Our Ref: B20364.L001/JAW/srm

Date: 5<sup>th</sup> March 2015

**Re: Alterations to Cote Royd House, Former Stable Building,  
7 Halifax Road, Edgerton, Huddersfield, HD3 3AN**

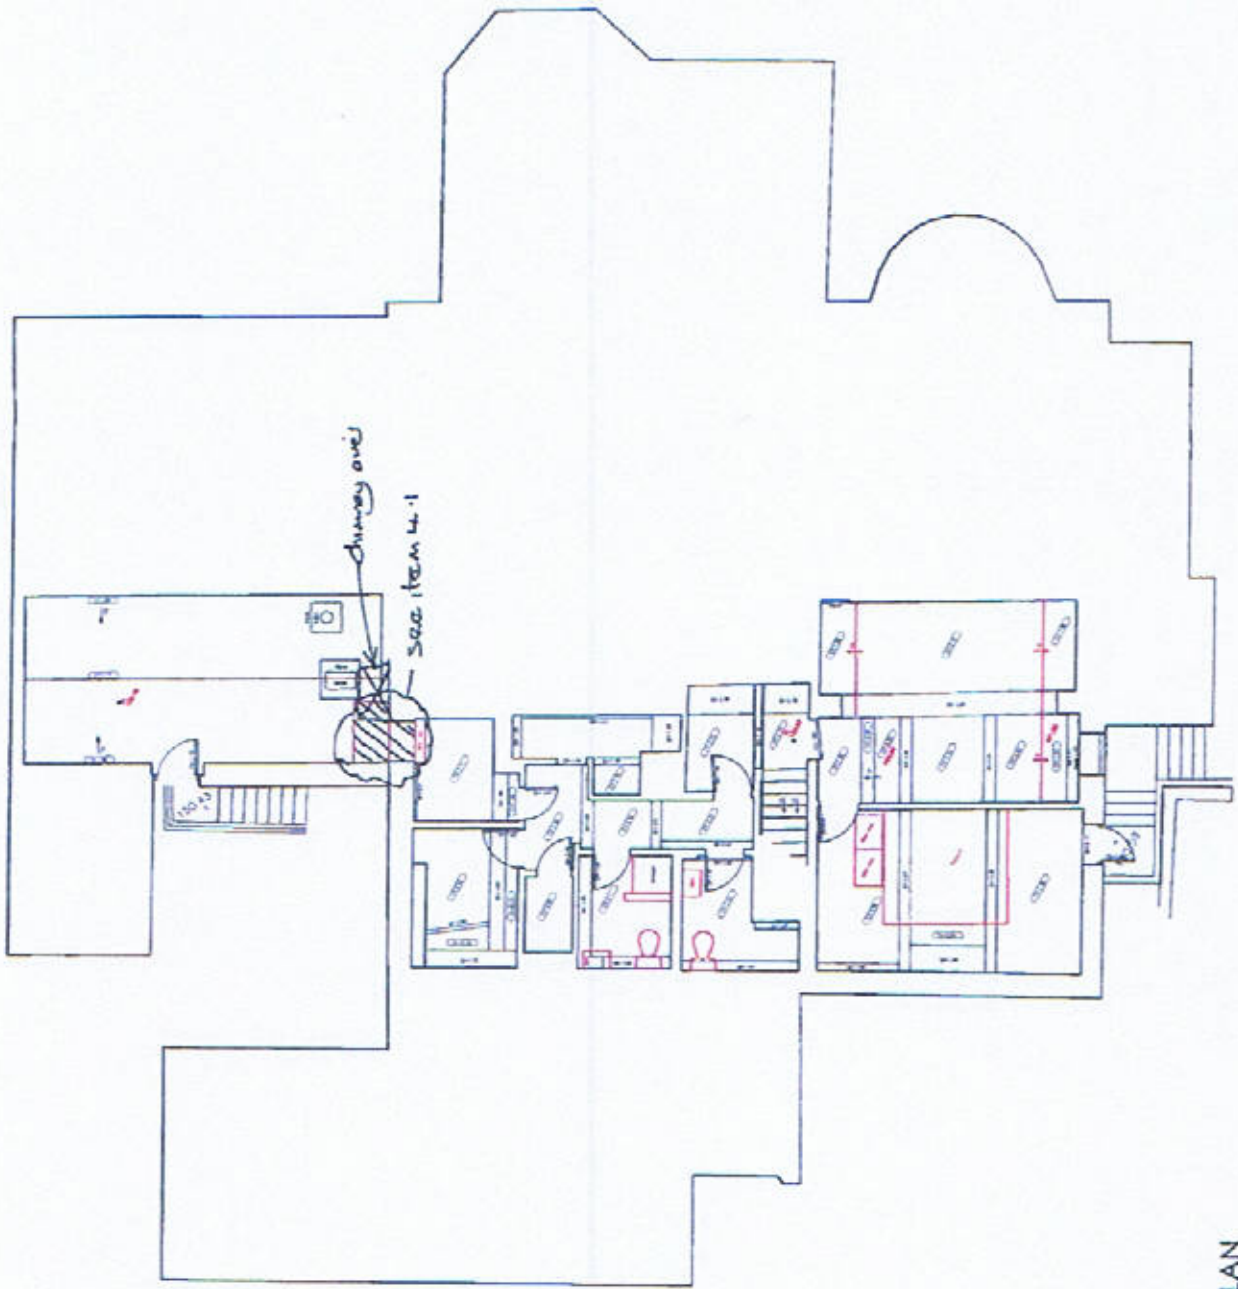
The corridor walls are to be removed in the 1970's extension. These are all timber stud partitions and are non-load bearing. In addition to this the masonry walls which run front to rear are to be removed and these again are non-load bearing walls and can be seen within the roof space to exit through the ceiling boards. This more clearly described on Sketch SK1 appended.

Again the corridor walls in the 1970's building are to be removed and these are once again timber stud partitions. The masonry walls between the rooms running front to rear in this case carry the first floor joists and at a lower level the old flat roof joists. This arrangement has been clarified on Sketch SK1. Steel beams will be required to run front to rear to support the light weight timber structures of the first floor and flat roof only. A number of piers will be left in place to ensure that these beams are kept to a minimum size. It would be subject to the final layout by the Architect.

NOTE 1: TRUSS RAFTER ROOF - SPANS FRONT TO REAR

NOTE 2: First Floor walls are not load bearing and may be removed

NOTE 3: Ground floor walls to be replaced by steel beams to support first floor and old flat roof

NOTE 4: The 1970's extension appears to have been built in 2 stages as the hotel expanded. First was single storey with flat roof then first floor added with pitched roof.

CELLAR PLAN  
 Scale 1:100

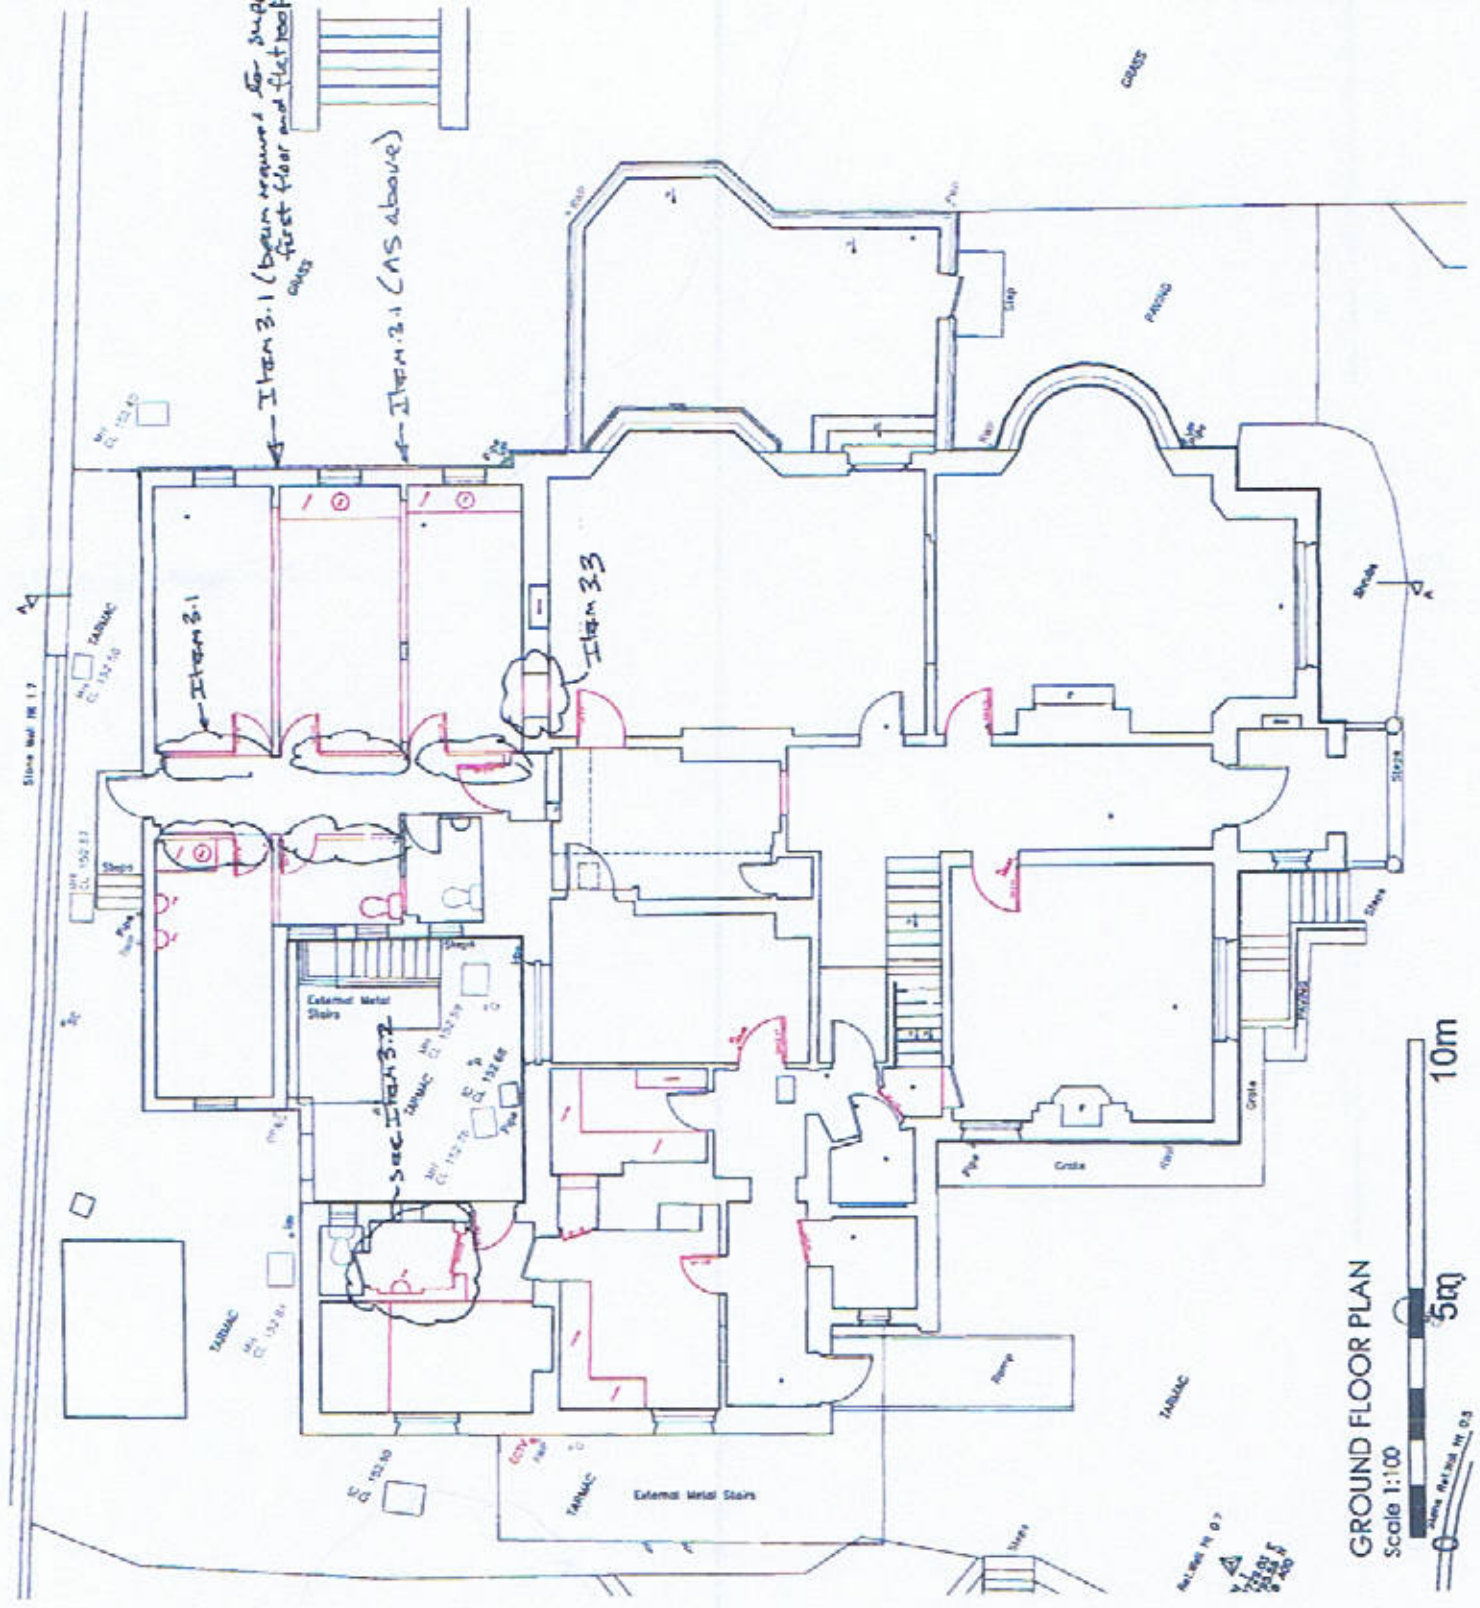
A new narrow door opening is required to link the vaulted cellar to the main cellar. Some investigation is required in this area as it is at the location of a chimney breast. An inspection of the main chimney stack shows that this is offset from the chimney breast and appears to rest directly above the vaulted ceiling to the cellar. There is possibly a transition beam above the cellar taking the load of the chimney onto the front and rear walls of the cellar. Again a Structural Engineer should investigate this area during the course of the work, however, at this stage we envisage the inclusion of further masonry walls directly below the upper chimney stack which should be seated on to a new concrete foundation within the vaulted cellar.

**GROUND FLOOR PLAN**  
 Scale 1:100

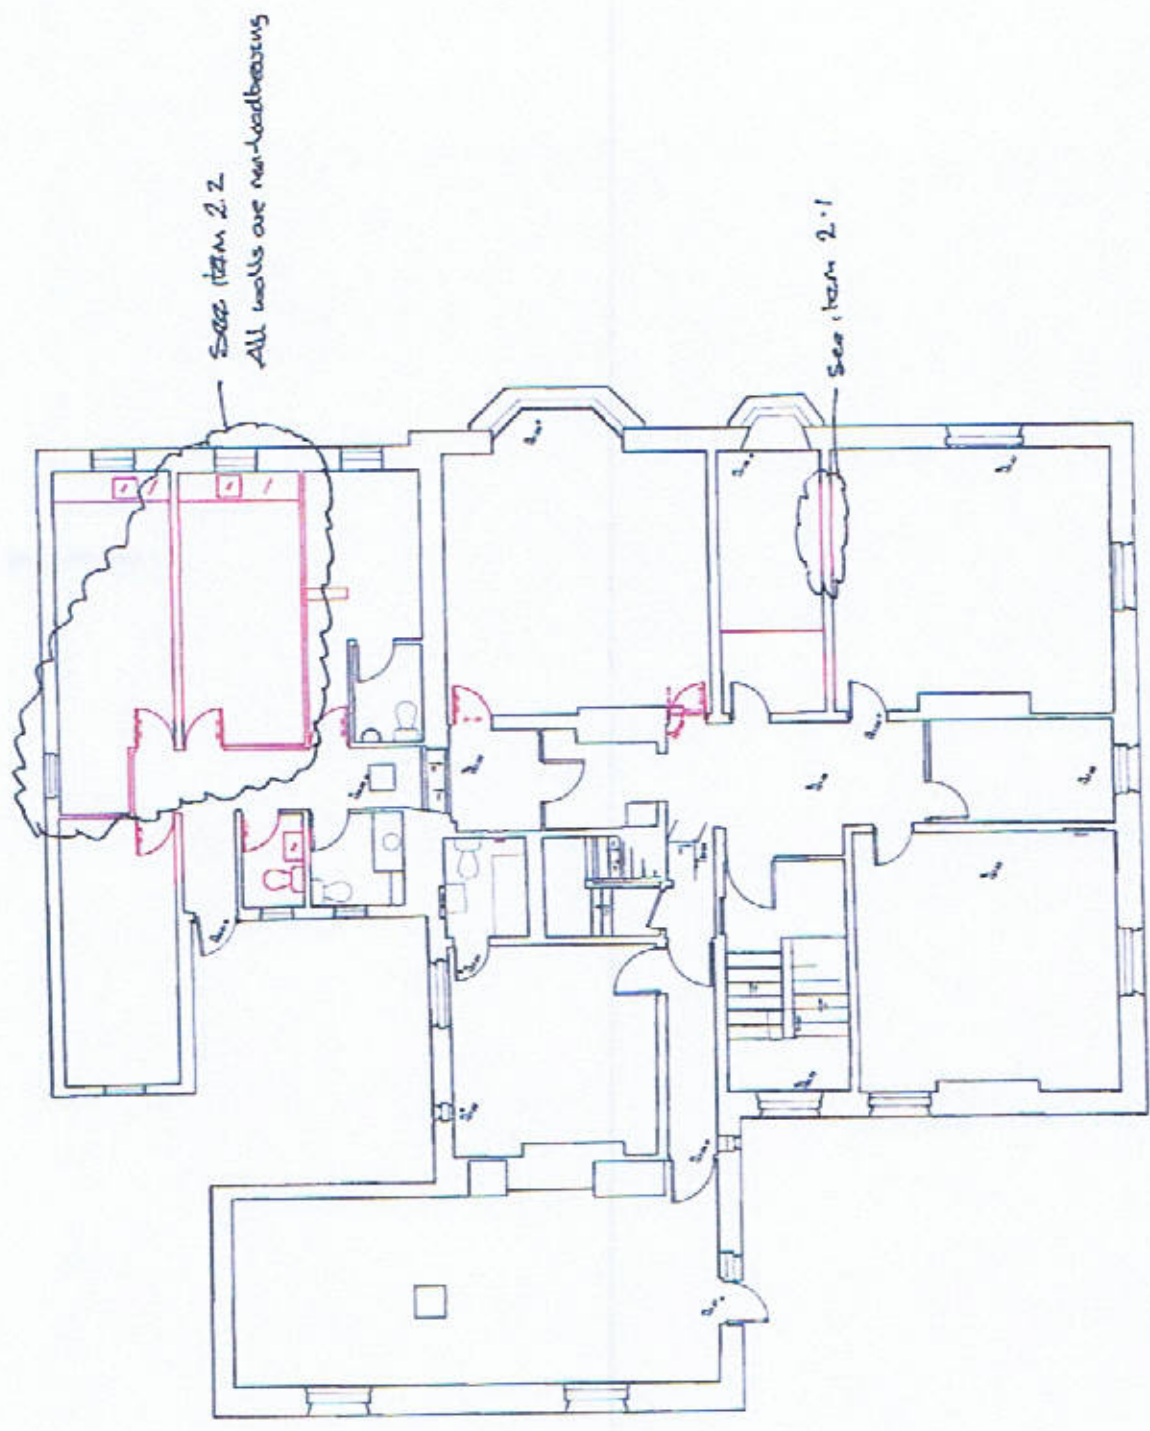
The rear right hand corner room has a small room with a sink. These walls are stone and appear to be non-load bearing. However, careful removal of these walls should take place ensuring that the first floor timbers are not bearing on to the walls. There are no walls in the room at first floor level directly above this area. We recommend that a Structural Engineer inspects this area at the start of the work to confirm whether steel or timber supporting beams will be required to support the floor structure.

There is a new door opening in the central room and again this is the re-opening up of the door that was previously at this location which has been blocked up using timber.

**FIRST FLOOR PLAN**  
 Scale 1:100  
 0 5m 10m

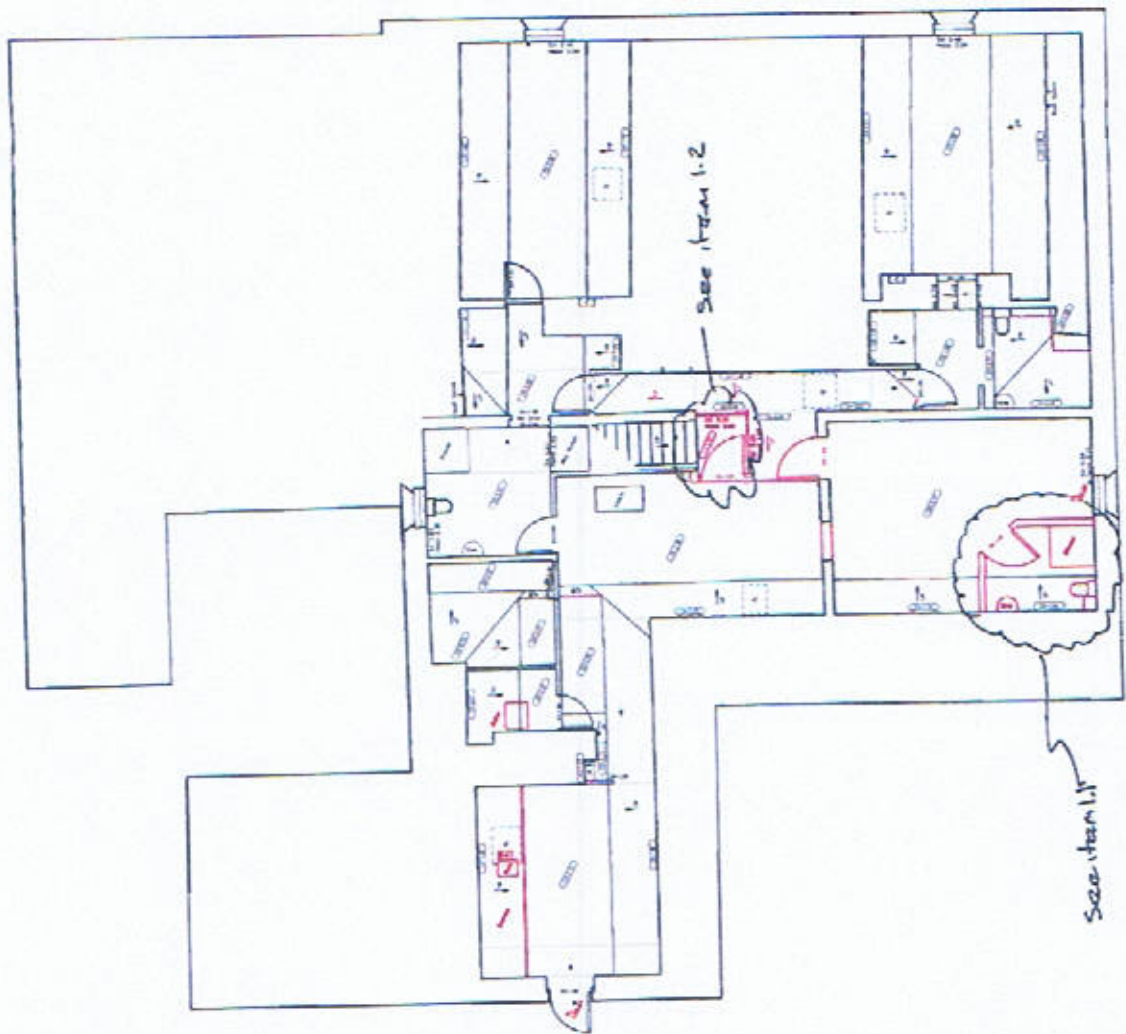
A new opening is required between the left hand room and the central room. The new opening is at the location of a previous opening between the two rooms and is returning the structure back to its original. There are no structural implications with regards to this new opening.
